STAFF REPORT SUMMARY

To: Edgerton Planning Commission
Fr: Kenneth Cook, AICP, CFM, Community Development Director
Re: PS2017-02, Preliminary Site Plan for LPKC Lot 3 – Inland Port VI, located on the South side of 183rd Street and East of Montrose.

STAFF REPORT

To: Edgerton Planning Commission
Fr: Kenneth Cook, AICP, CFM, Community Development Director
Re: Application PS-2017-02 for Preliminary Site Plan for Logistics Park Kansas City, Inland Port VI, located at the southeast corner of 183rd Street and Montrose Road.

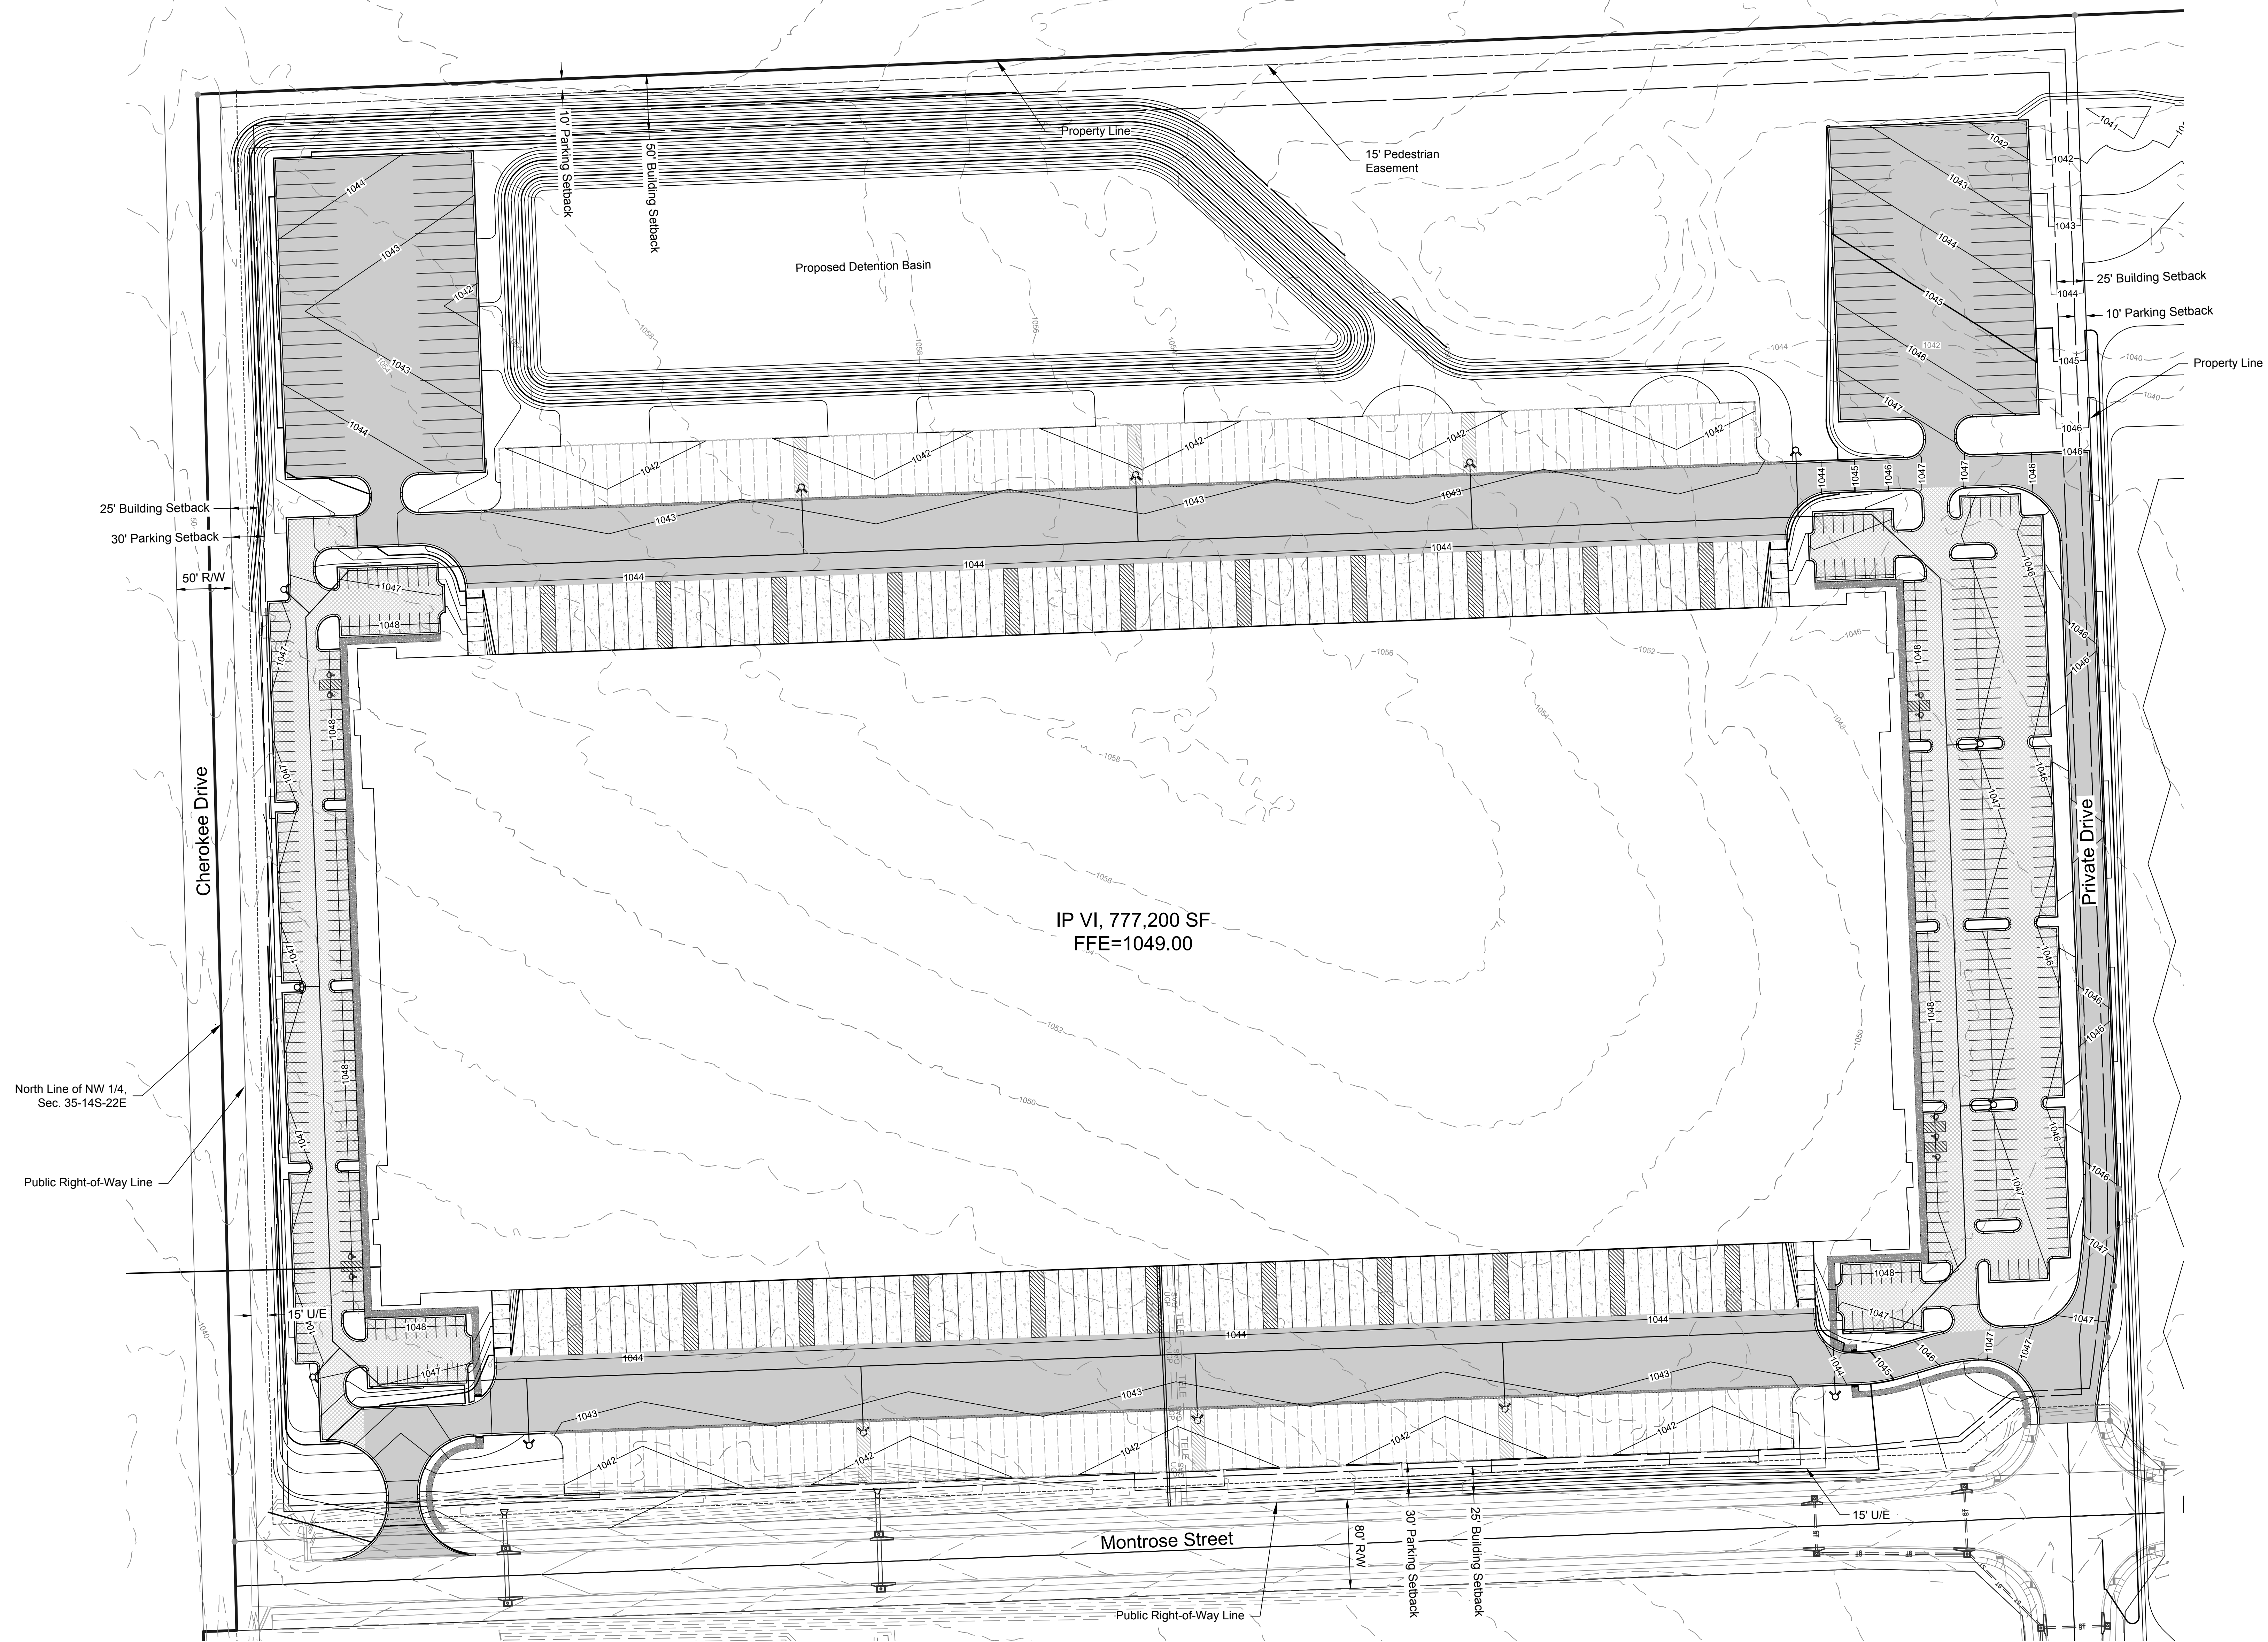
3. Sheet #3
 - a) A site map with the following features.
 - i. Topography at reasonable intervals. ***Additional labels for elevations should be provided, especially for contours around the detention basin and trailer parking are on Northeast portion of site. Update Preliminary Site Plan.***

- ii. Exterior lot lines with any survey pins. *Verify property boundary as it appears the NW corner of the lot is shown extending into the street improvements. Additionally, verify if the centerline of 183rd and the Section line of 35-14-22 are the same. Current map shows Section line not being centered in ROW. Identify the corporate city boundaries.*

- iii. Location of buildings. *Preliminary Site Plan complies.*
 - iv. Parking areas, paths, walks with sizes and surfaces material specifications. *Dimension the distance between property lines and all parking areas.*

- v. Exterior lighting specifications. *Details, locations and photometric plan have not been provided.*
 - vi. Site entrance and connections to streets. *The southwest access point for Lot 3 raise sight distance concerns that should be further evaluated by the city engineer and applicant. Provide modifications to this intersection to update the facility based upon current design and layout of road. Work with City Engineer to update layout of intersection and entrance.*

1. General. The plan addresses the general parking and loading requirements as follows:
 - a. Sufficient off-street parking spaces. Parking space dimensions of at least 9 by 20 feet per space are required. ***Please dimension vehicle and trailer parking spaces and label as typical.***

- 2. Parking Spaces and Aisle Surfaces. ***Preliminary Site Plan complies.***
- 3. Parking Space and Aisle Dimensions. ***Parking space dimensions of at least 9 by 20 feet per space are required. Other parking spaces and aisle dimensions should conform to Article 10.2, Parking and Loading Standards, as required. Please dimension one parking stall and one trailer stall and label as typical.***
